KAC Fashion Wear Ltd. (9674)

09.July.2014

Identified Priority 3 Concerns

Typical column to be checked

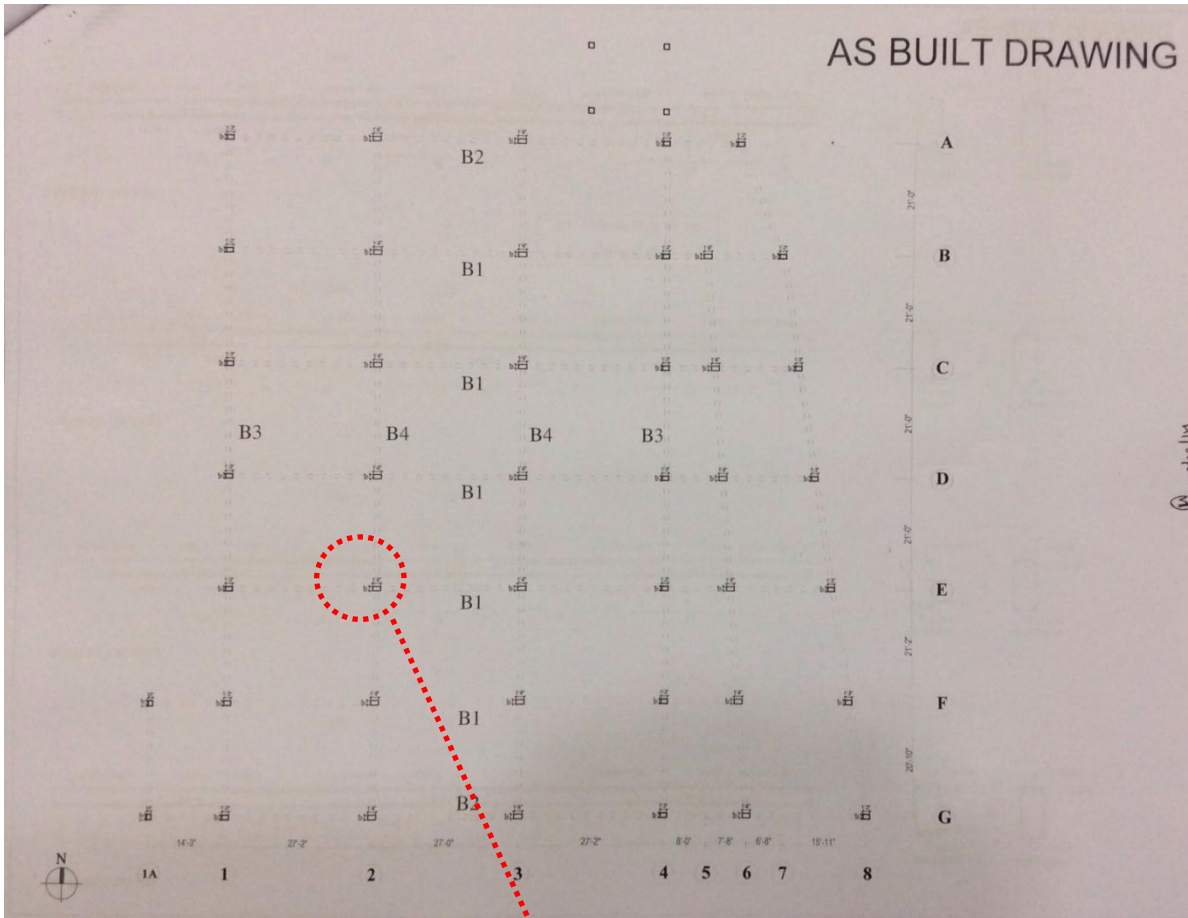
1st Priority 3 Concern

Based on the load rundown analysis with the agreed minimum design live load assignment, the typical column which is circled has been found to be possess a low factor of safety with respect to its load carrying capacity. The building was constructed with brick aggregate and high-yield strength re-bar.

Item No.	Observation	Recommended Action Plan	Recommended Timeline
1	1st Priority-3 - The typical columns in building 1 have low factor of safety with respect to their load carrying capacity.	Carry out a full Detailed Engineering Assessment of the entire building including any intrusive testing required Building Engineer is to fully check the loading capacity of all components to determine whether or not the as-built components are able to sustain the applied loads.	6-weeks
2	1st Priority-3 - The typical columns in building 1 have low factor of safety with respect to their load carrying capacity.	Implement the steps as required from a DEA.	6-months
3	2nd Priority 3 - Inconsistency between drawing and real site condition in building 2	Factory Engineer to check full structural system to verify whether the slabs, columns are able to support the applied loads	6-weeks
4	2nd Priority 3 - Inconsistency between drawing and real site condition in building 2	Factory Engineer to revise the drawing record to reflect the real site condition	6-months

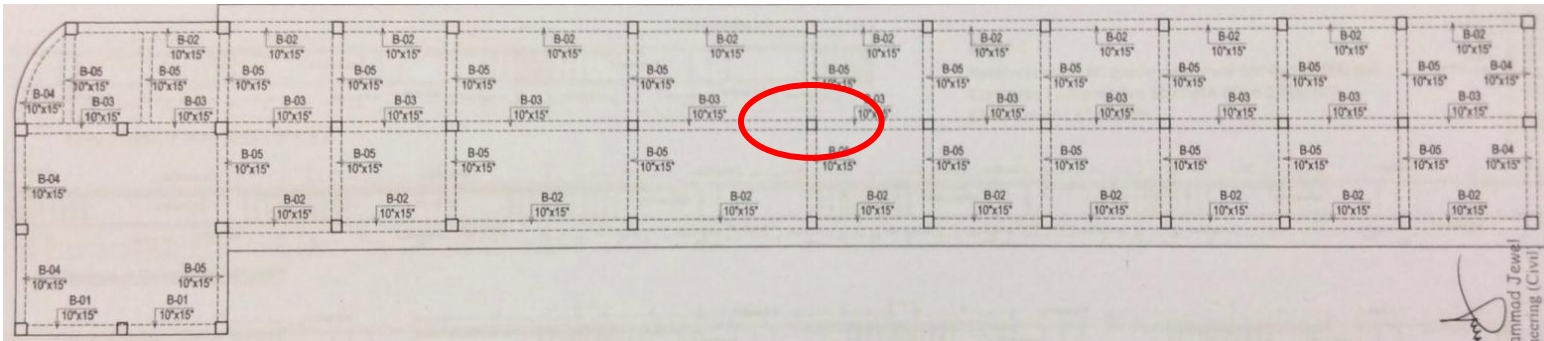
In building 2 some columns are missing in middle grid. Columns in indicated area are missing for all three storeys.
